NEW DESIGN SK18

Rendering 18

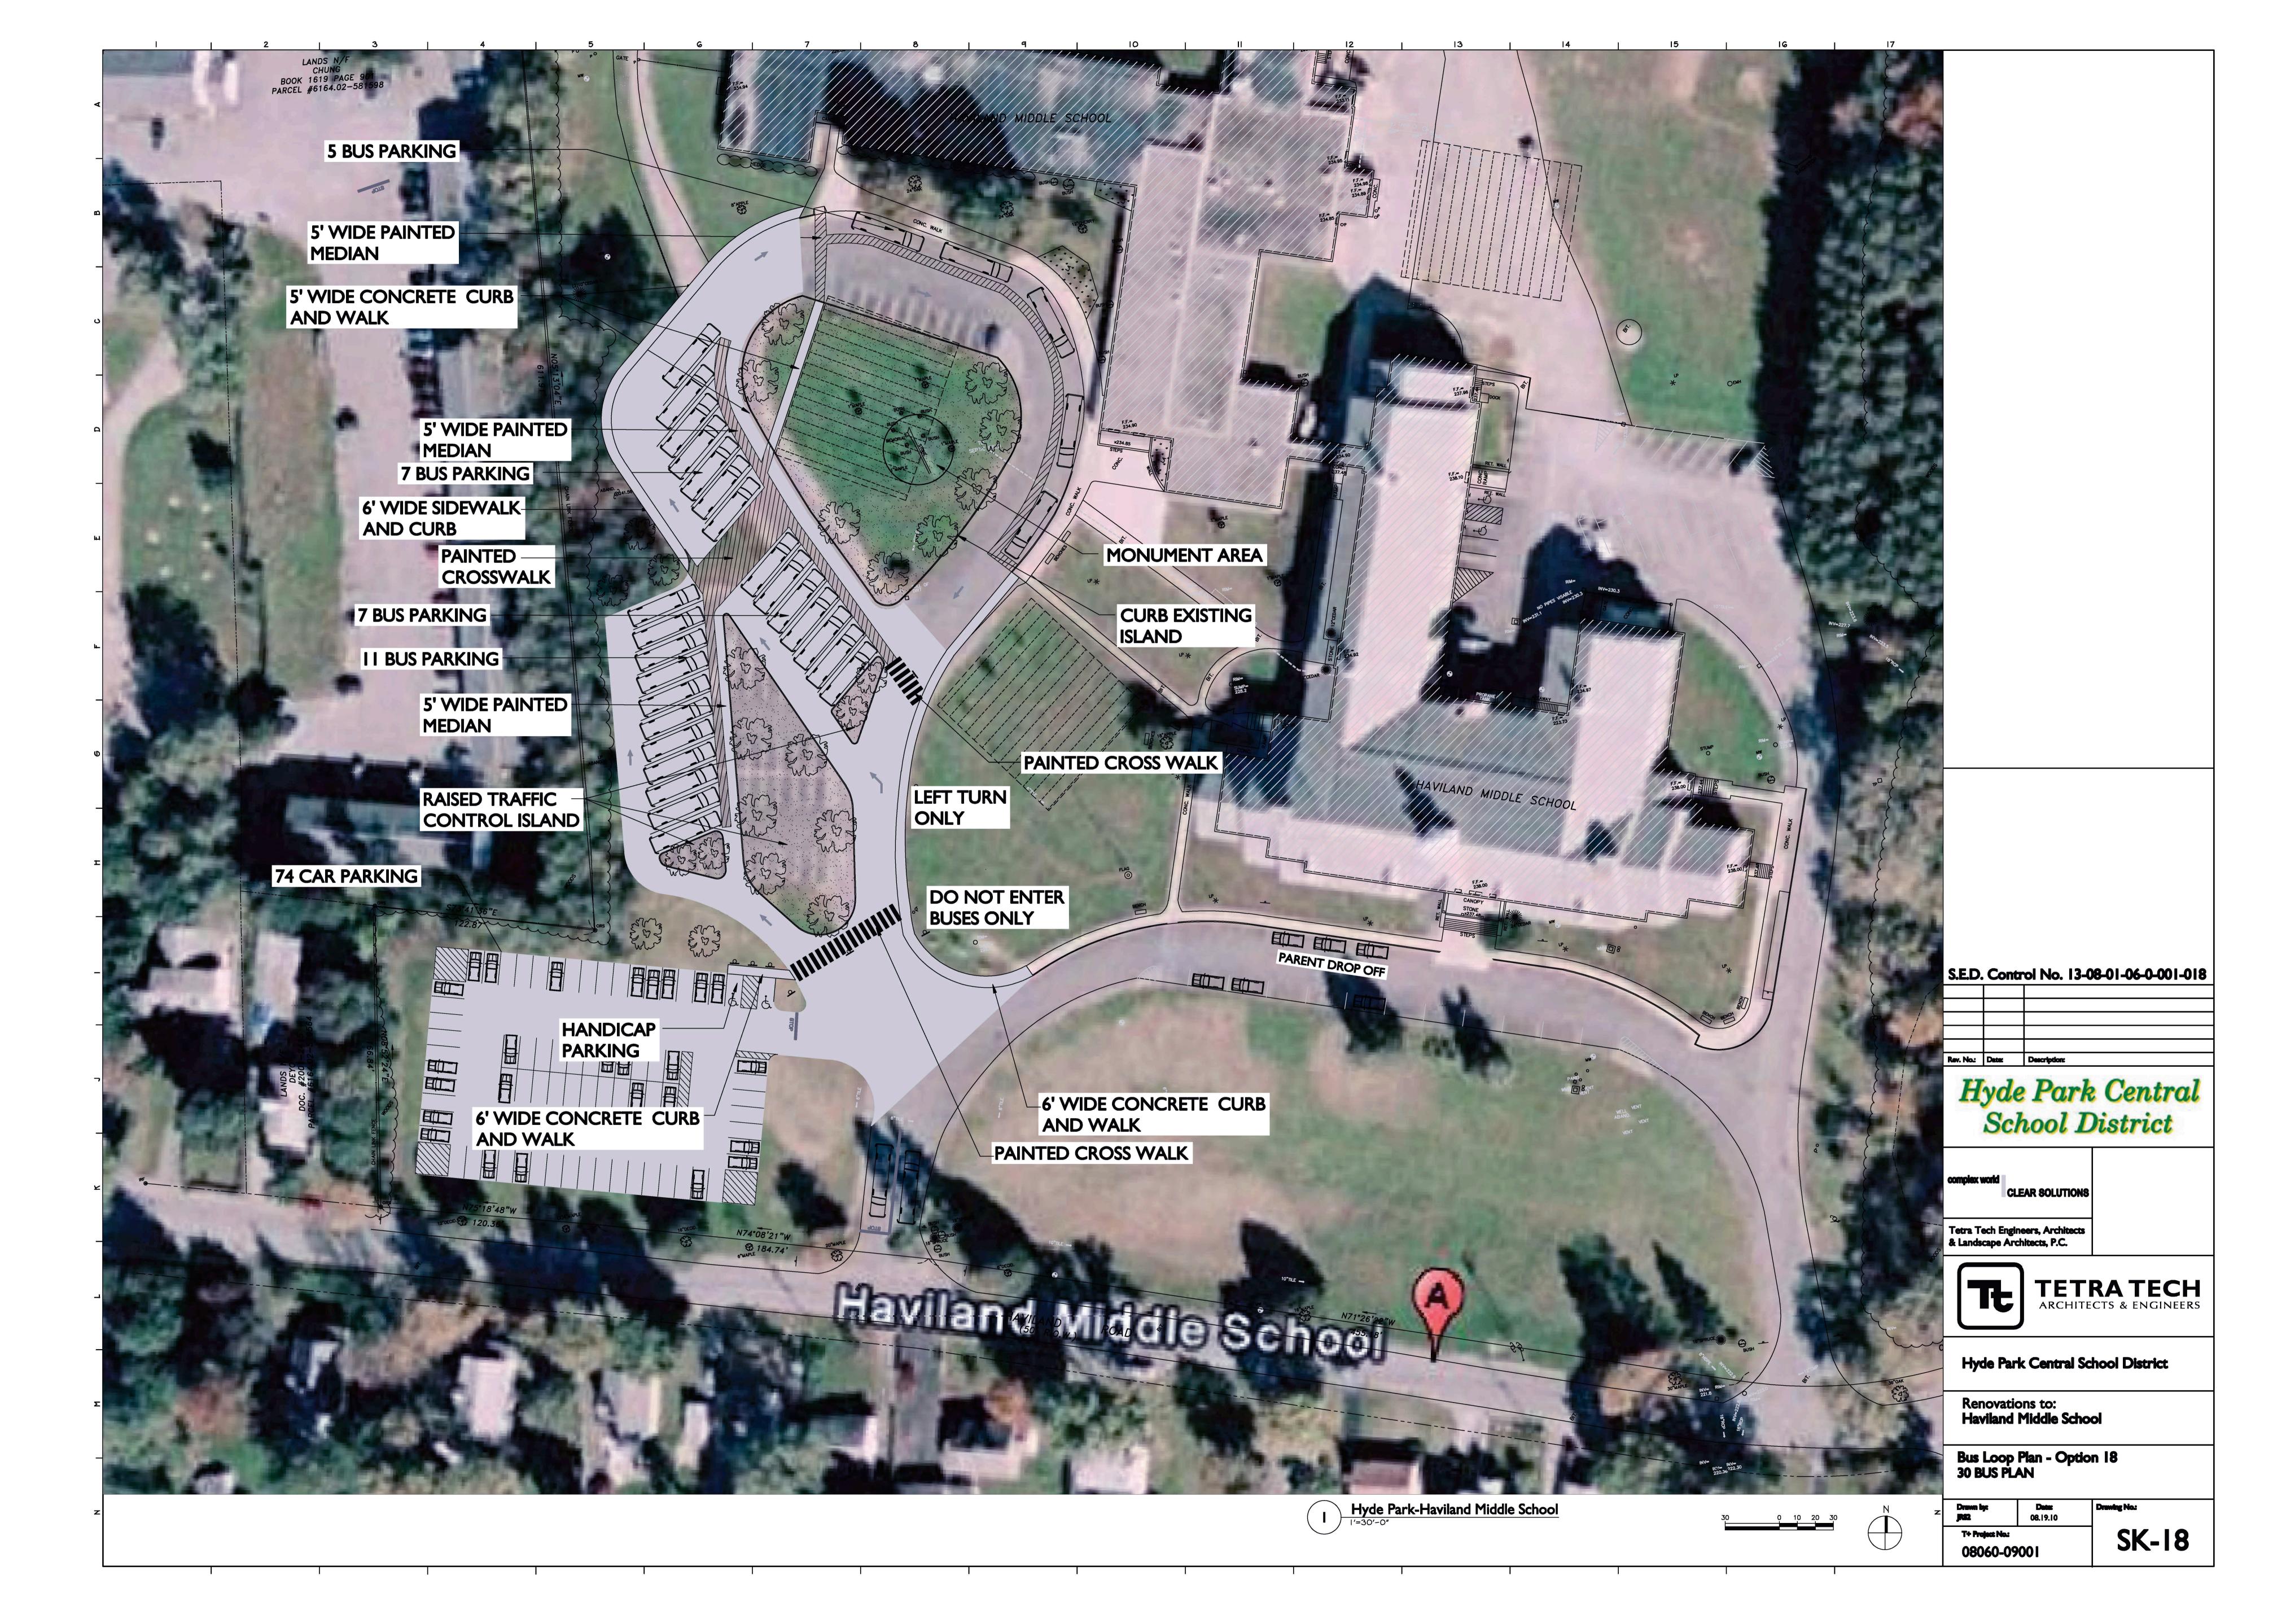
SK18: This design also allows for side-by-side, angled parking for all busses. Although it does call for a double-row of such parking, it provides for raised crosswalks and/or sidewalks. It is within the budget.

- No aesthetic change, maintains the current front curve and lawn in its entirety.
- No affects on septic fields or 911 memorial
- Multiple outside door access reduces student congestion upon entering / exiting building
- Assigned permanent bus spaces, accommodates late arrivals
- In Prop III budget

- Excessive cross walks, difficult to supervise all areas
- More complicated layout
- Nose to tail line up (partial)
- Double lineup (partial)
- Busses located away from building
- Handicapped parking in loop
 / limited access during arrival and dismissal
- Parent exit shared with bus traffic
